Number **D/695/2015**
Location 2 and 4 Clark Street RESERVOIR VIC 3073
Description Construction of **eight (8) double storey dwellings** and the **waiver of one (1) visitor car parking space a**s shown on the plans accompanying the application.

D/695/2015 2-4 Clarke St Reservoir

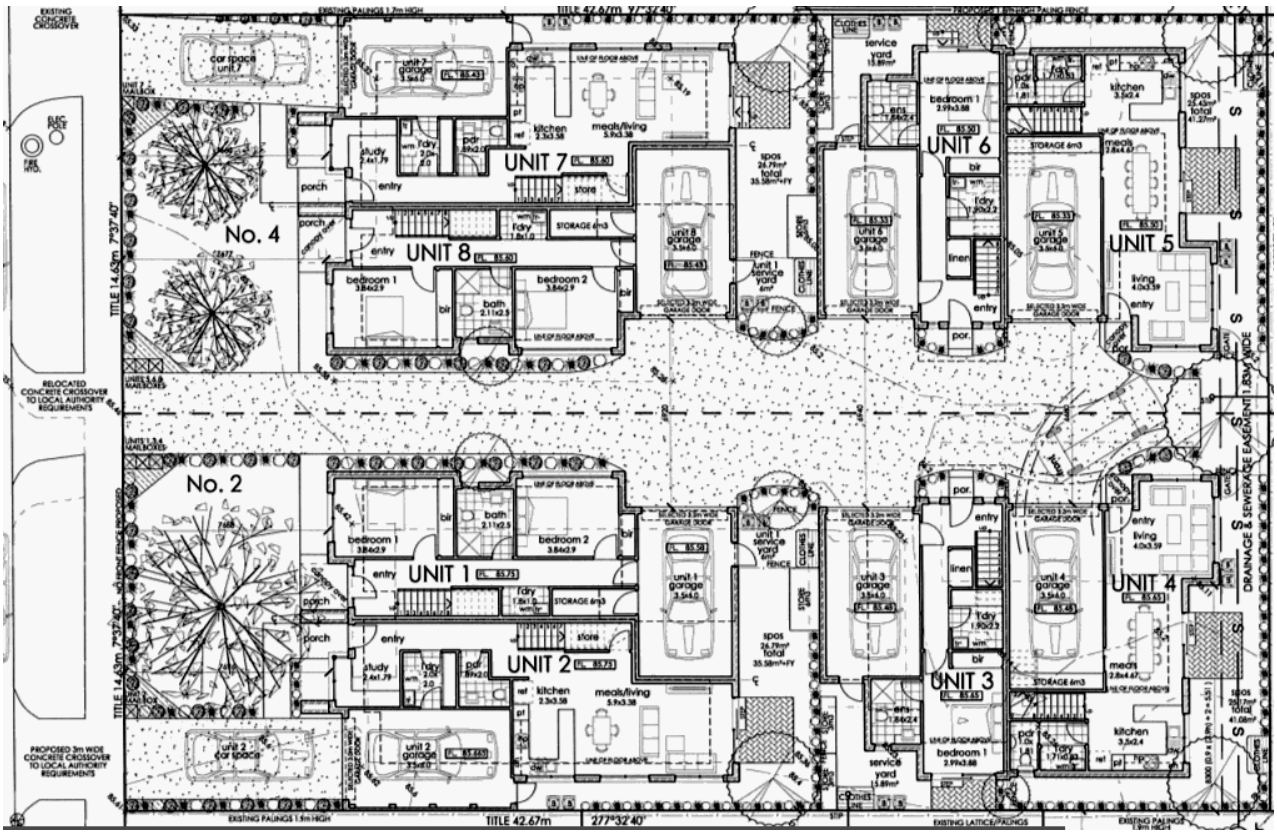
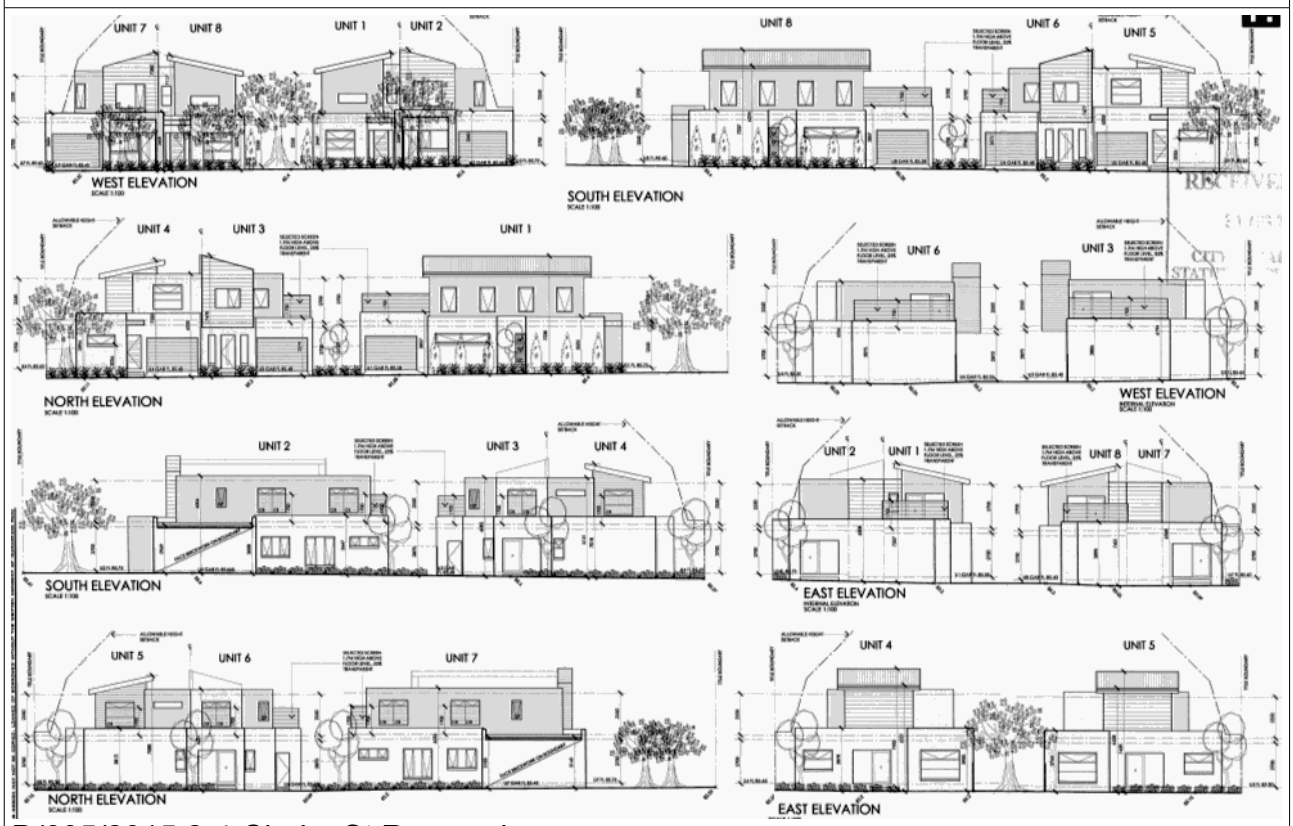
summary replace 2x family homes with 8 units = **2x 3 bed plus 6x 2 bed units**
Entire site consumed except for
no building over sewer easement along rear (E) boundary

http://planningschemes.dpcd.vic.gov.au/schemes/vpps/52_06.pdf
4 space, rule is 2 space to each 3 or more bed dwelling
6 space, rule is 1 space to each 1-2 bed dwelling
1 space, rule is 1 space for visiors to every 5 dwellings
11 in total, and plans show 10 spaces
